Reference: 022067

May 20, 2024

Subject: Garberville Tanks Replacement Project – Addendum #1

Garberville Tanks Replacement Project

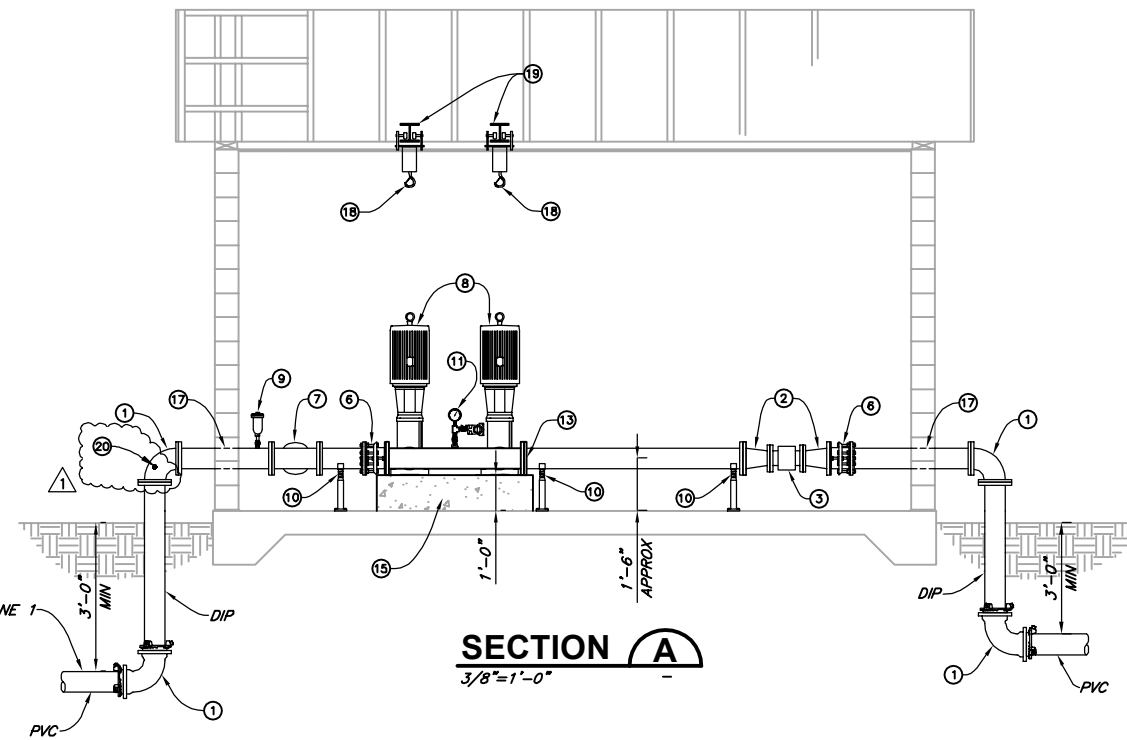
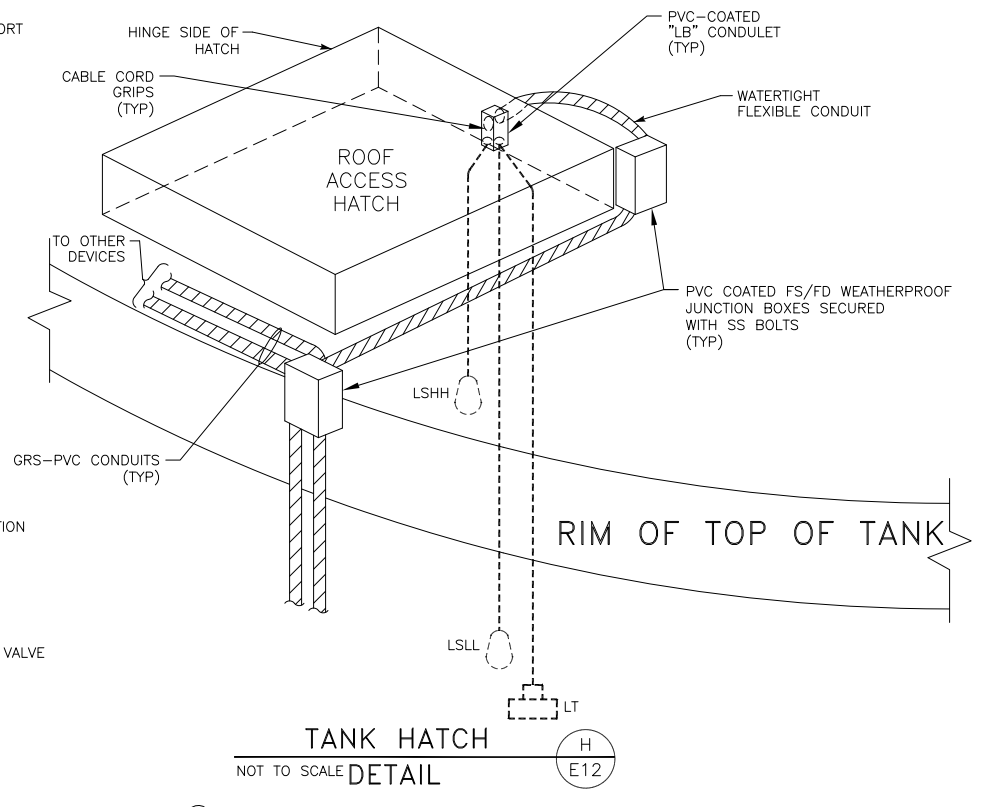
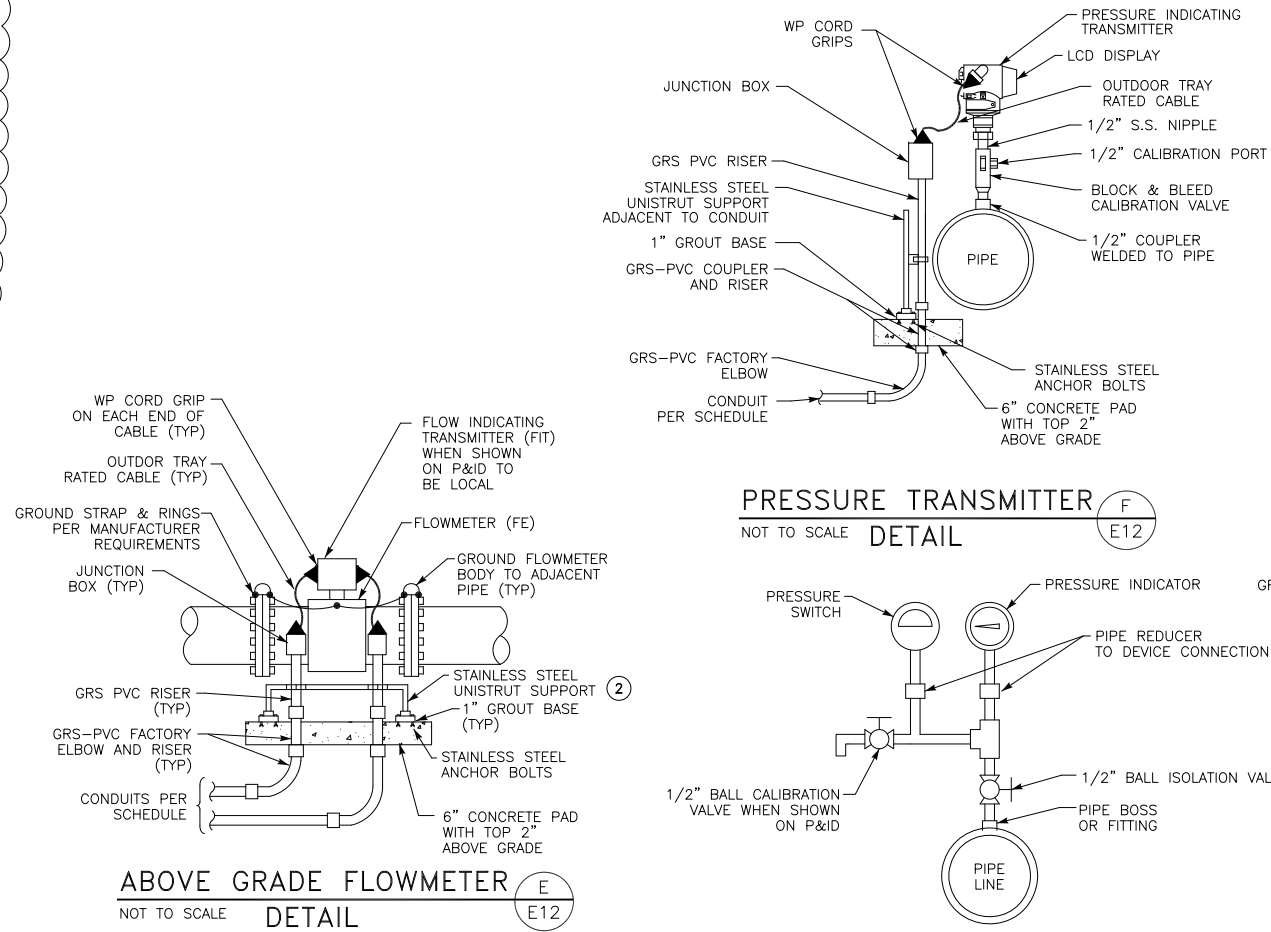
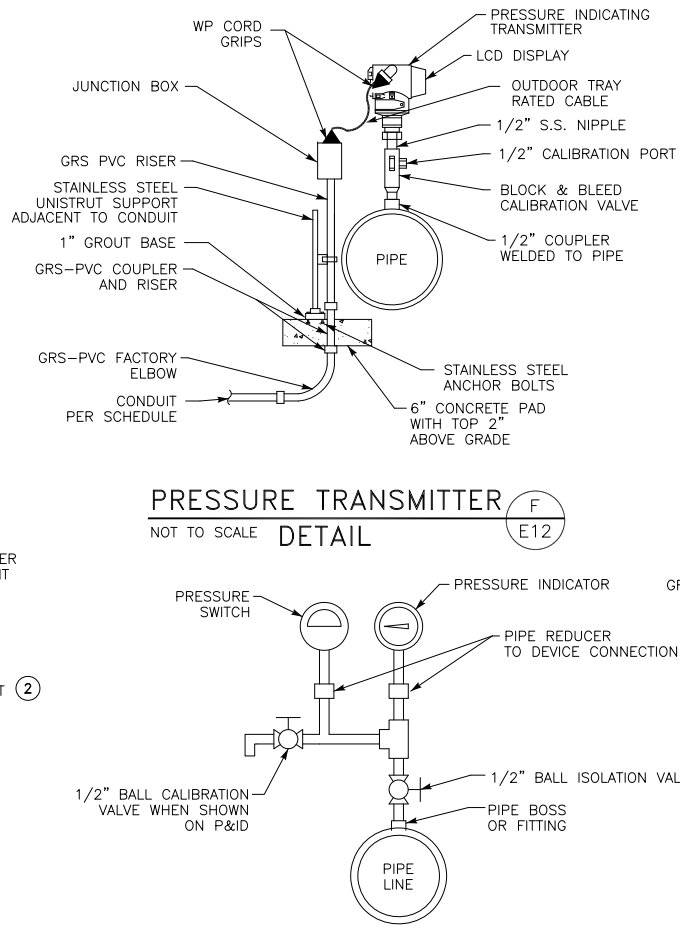
Item #1. Drawing C5.4 has been revised to include an external hose bibb at the Alderpoint Pump Station. Revised drawings are included in Appendix 2.

- ⑰ CMU WALL PIPE PENETRATION, SEE DET 4 ON SHT C8.4
- ⑱ 2 TON CHAIN HOIST WITH TROLLEY
- ⑲ HOIST BEAM, SEE STRUCTURAL PLANS
- ⑳ 3/4" HOSE BIBB WITH LOCKABLE LEAD-FREE STRAIGHT CURB STOP & 3/4" FACTORY TAP ON DIP ELBOW

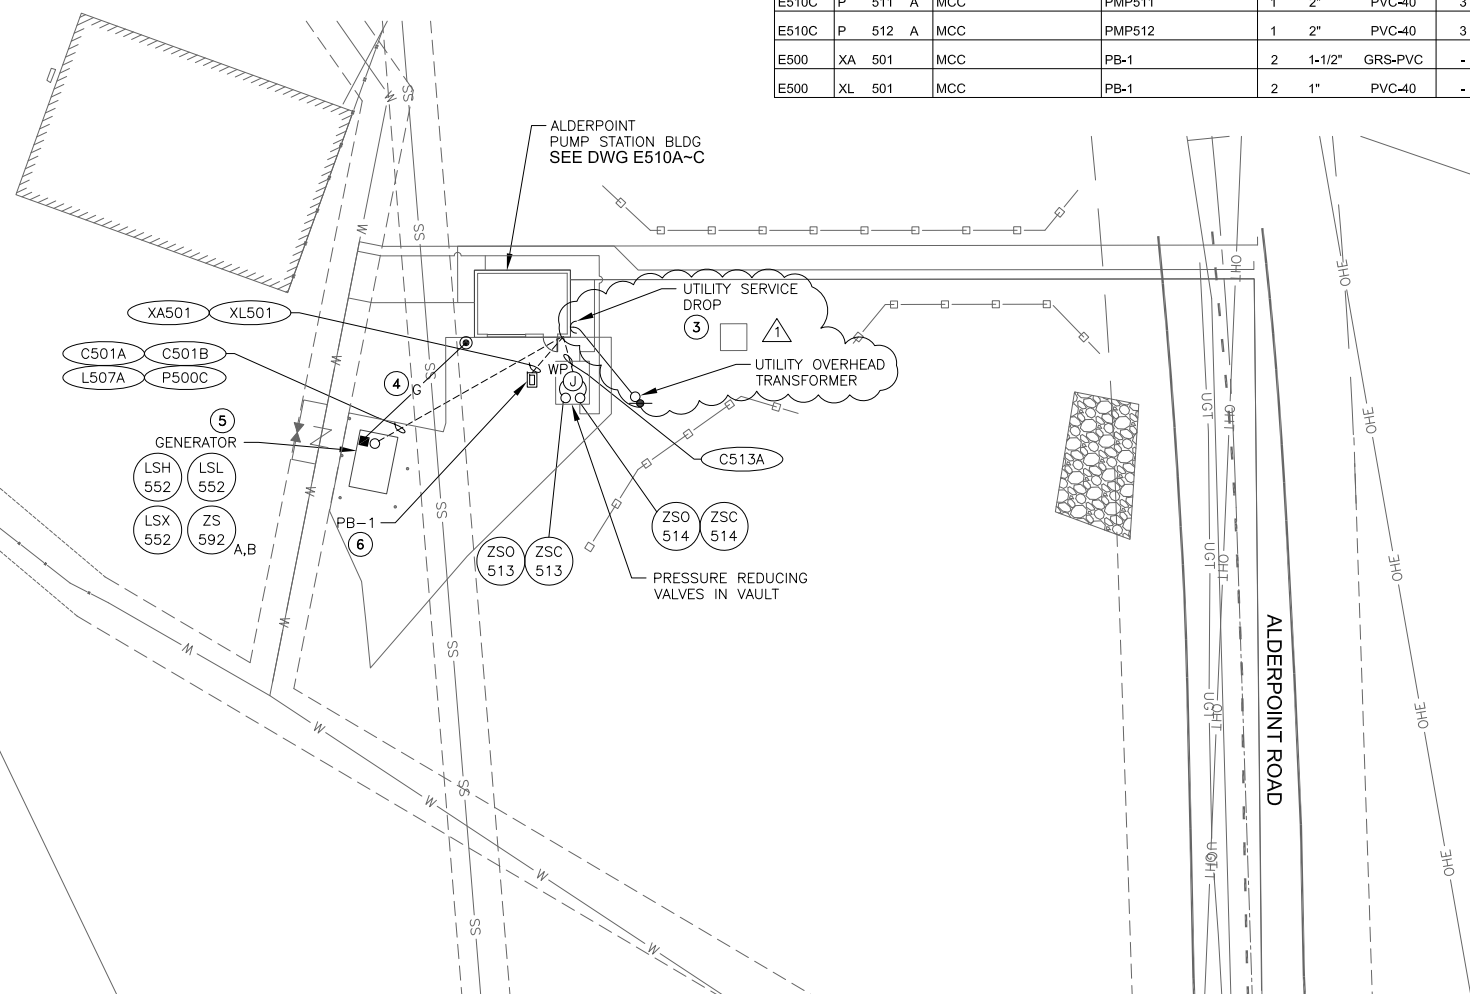
Item #2. Drawings E12, E500, and E510C have been updated to reflect changes incorporating the issued PG&E construction drawings. Revised drawings are included in Appendix 2.

**PG&E Construction
Drawing**

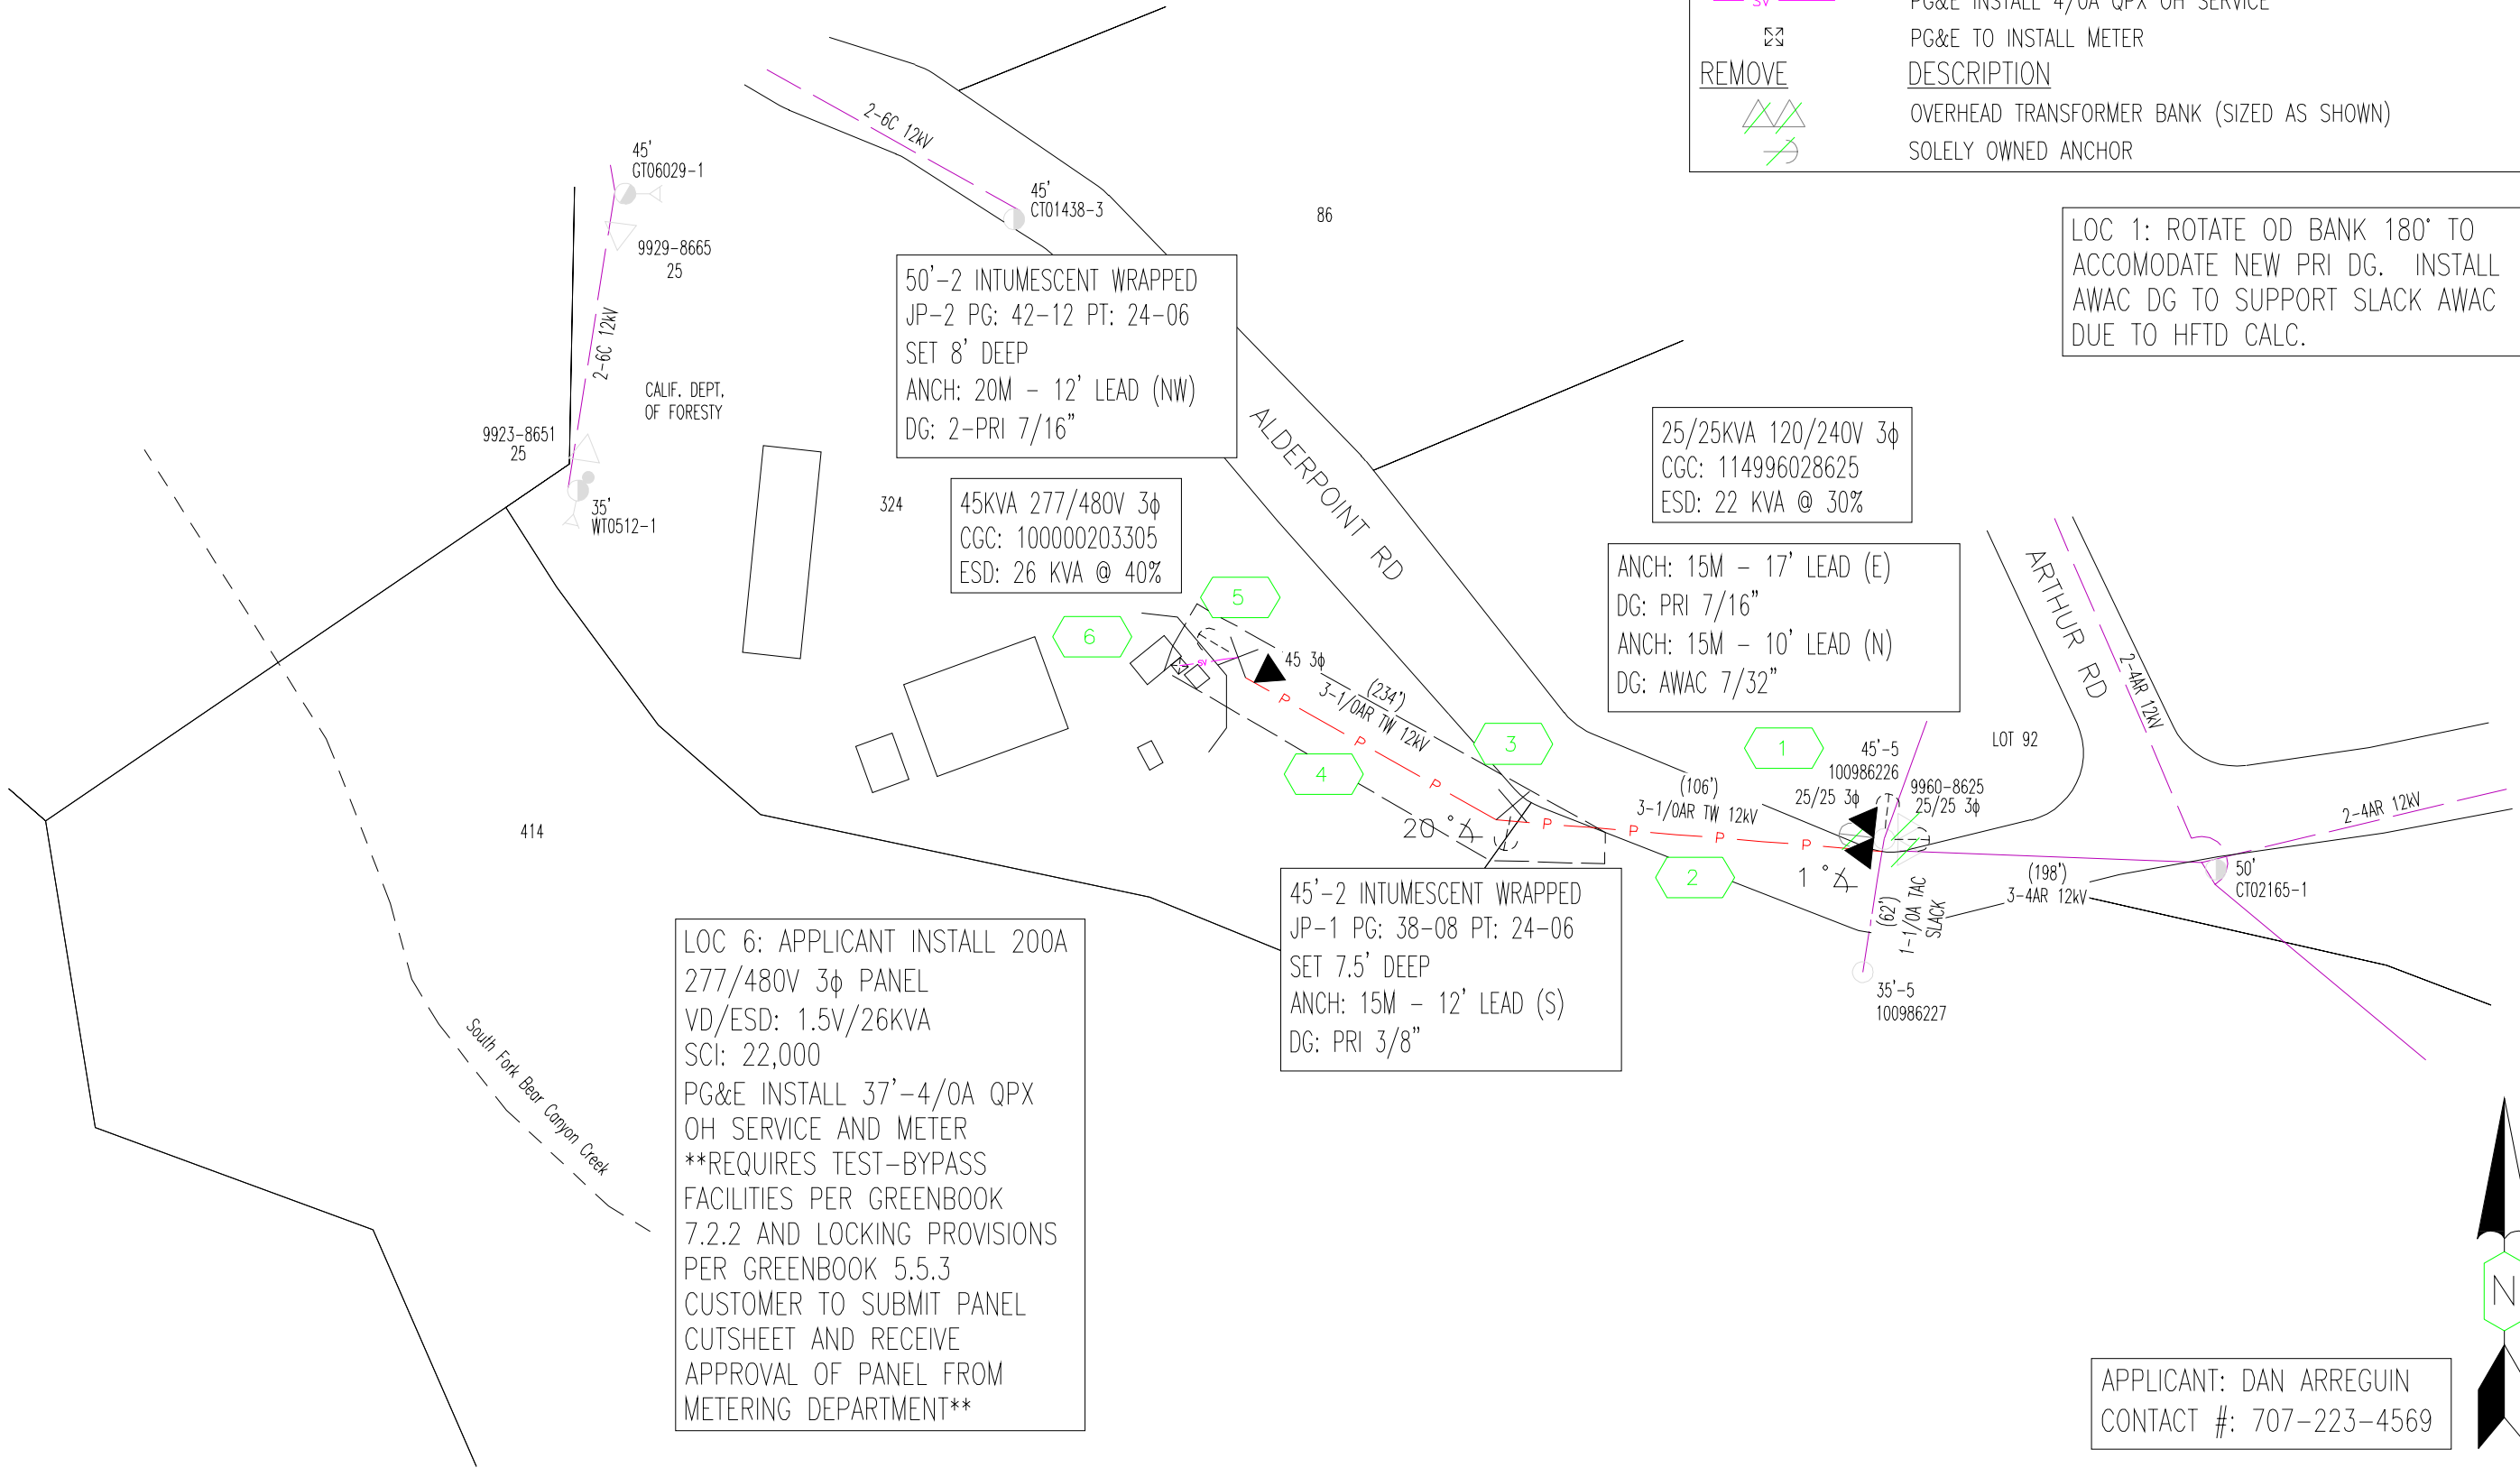
Item #2. A PG&E construction drawing for the electrical service at the Alderpoint Pump Station is included in Appendix 3.

LOC 1: ROTATE OD BANK 180° TO ACCOMODATE NEW PRI DG. INSTALL AWAC DG TO SUPPORT SLACK AWAC DUE TO HFTD CALC.
